CITY OF SHERWOOD
July 5, 2022
STAFF REPORT

SHERWOOD FESTIVAL PLAZA / PUBLIC PARKING LOT
SITE PLAN and CONDITION USE PERMIT
LU 2022-012 SP, CUP

To: City of Sherwood Planning Commission

From: Joy Chang, Senior Planner

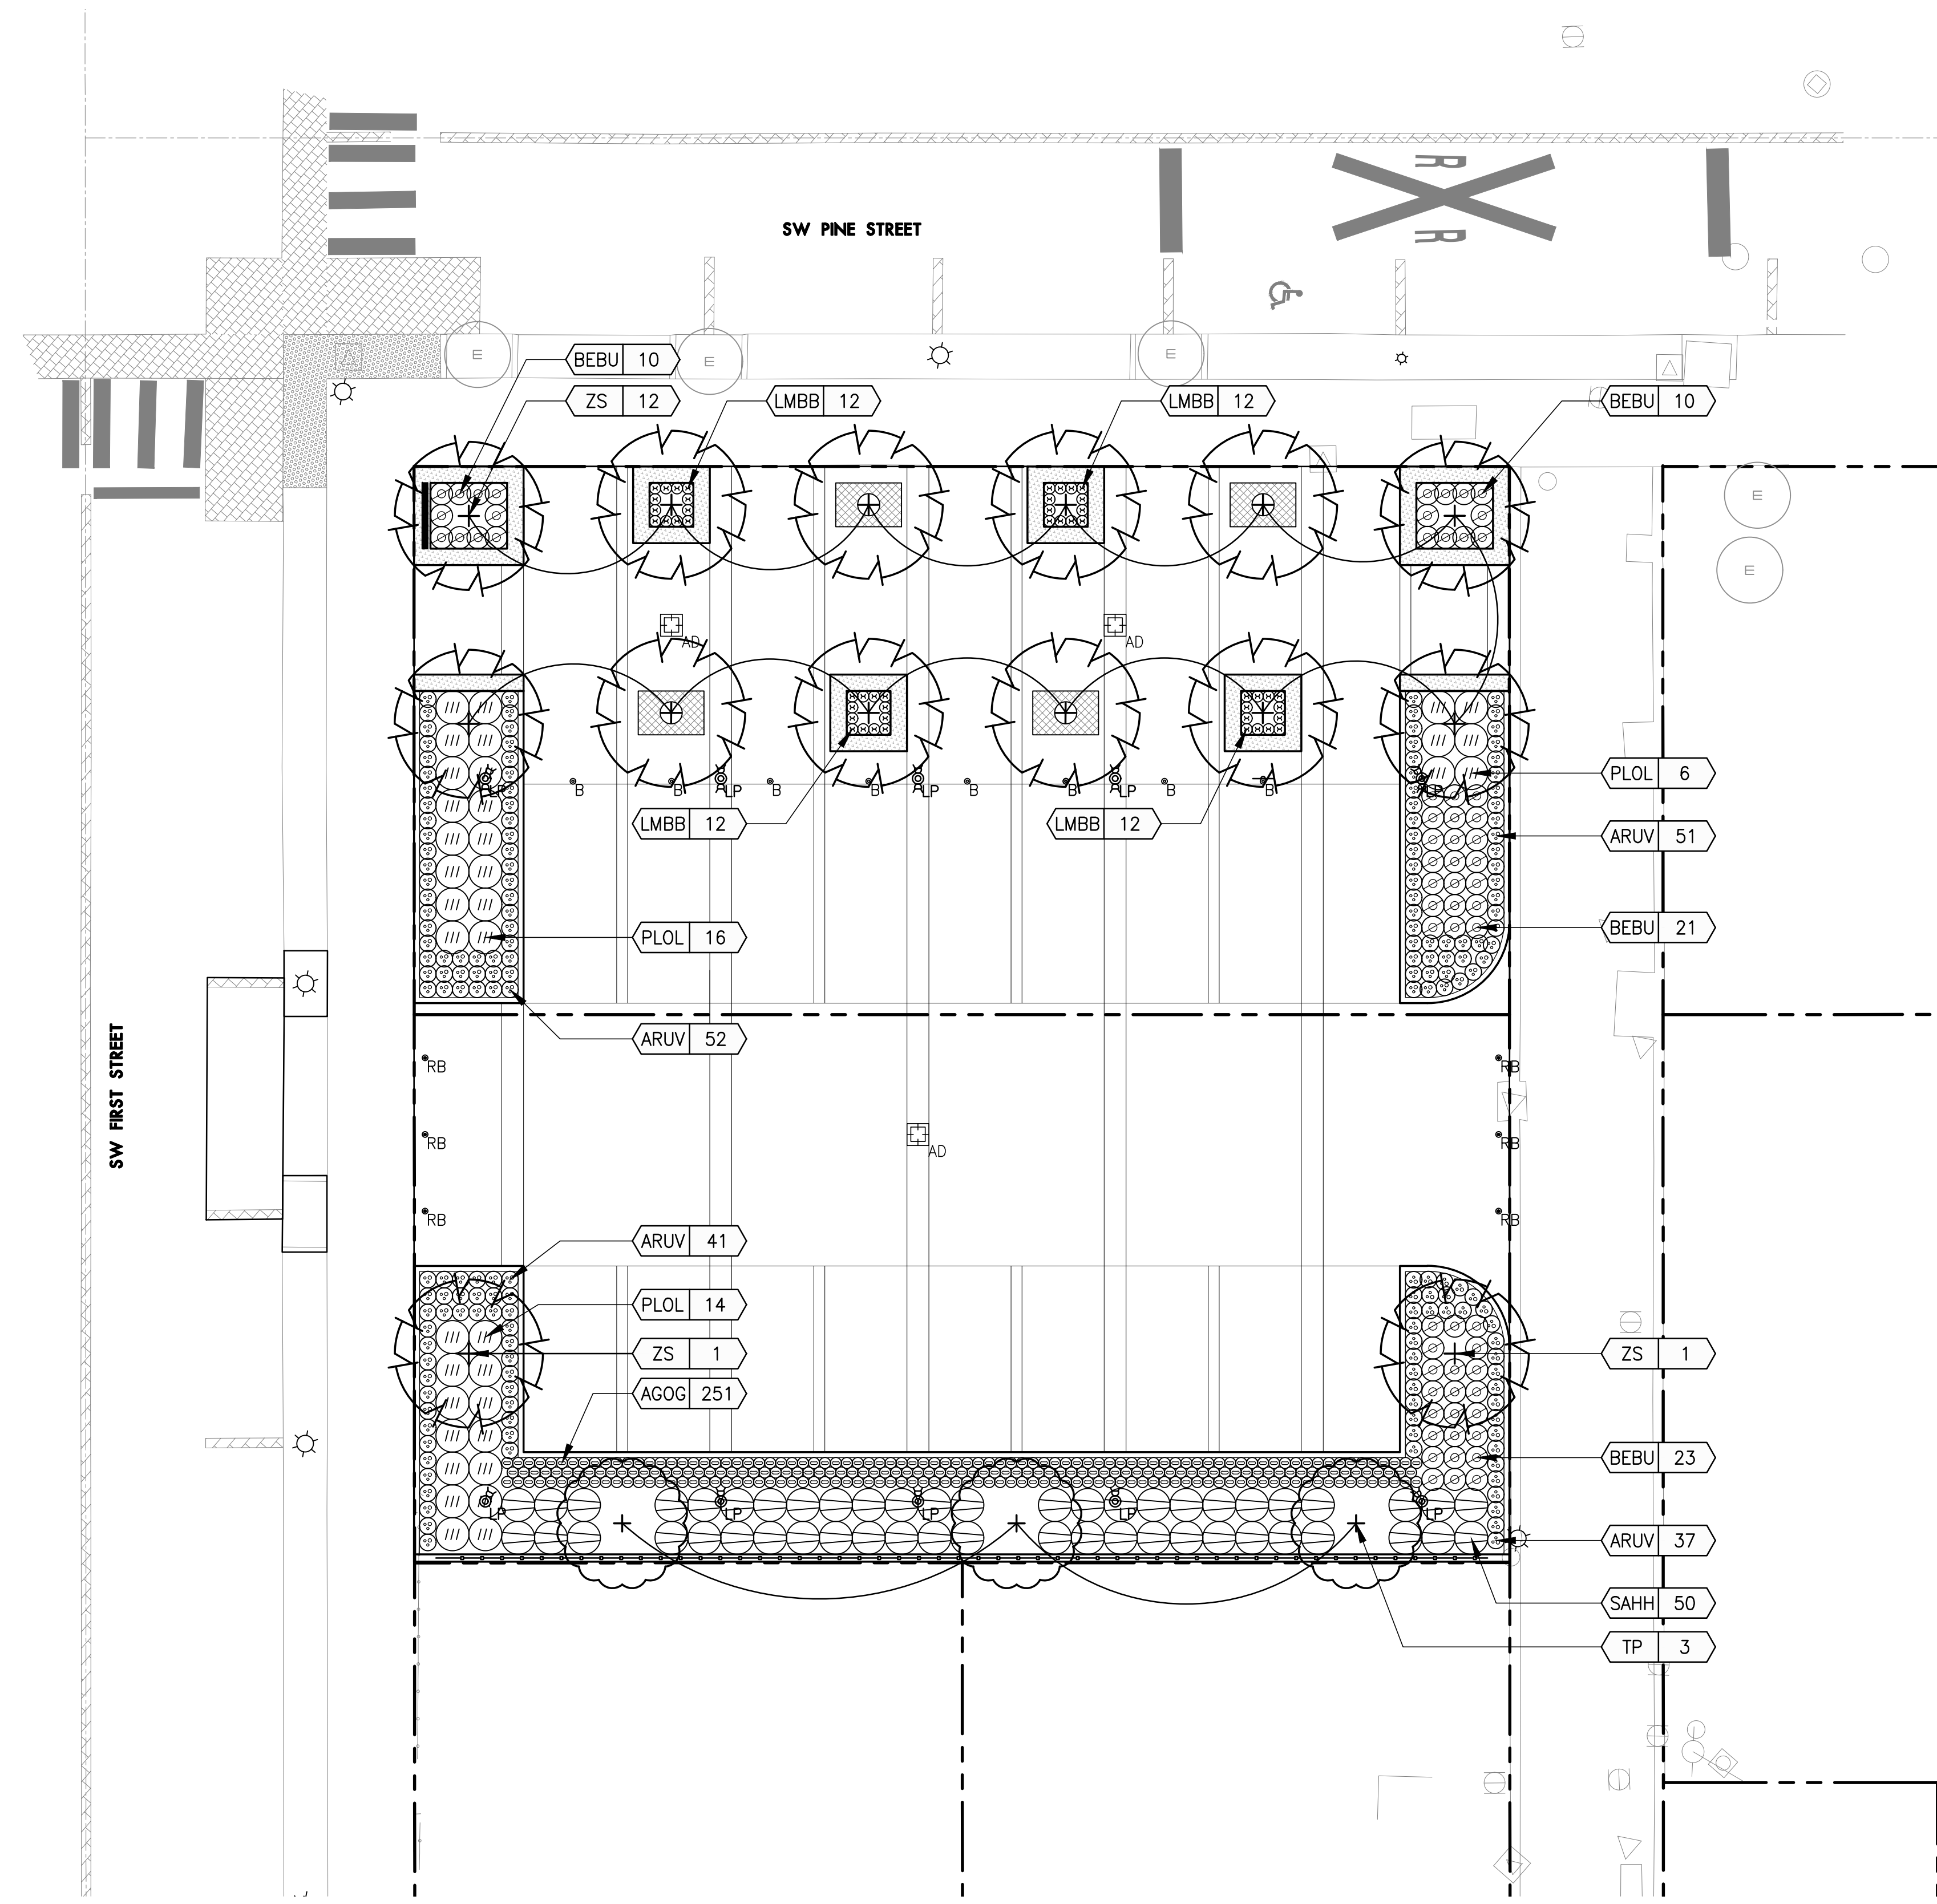
ANALYSIS: Staff concurs with the applicant's response above, with one exception. Sheet L401 shows 17 large trees instead of 11, as indicated on the applicant's narrative. The landscaping sheet showing 17 trees and the applicant's narrative stating 11 trees both exceed the number of large trees required.
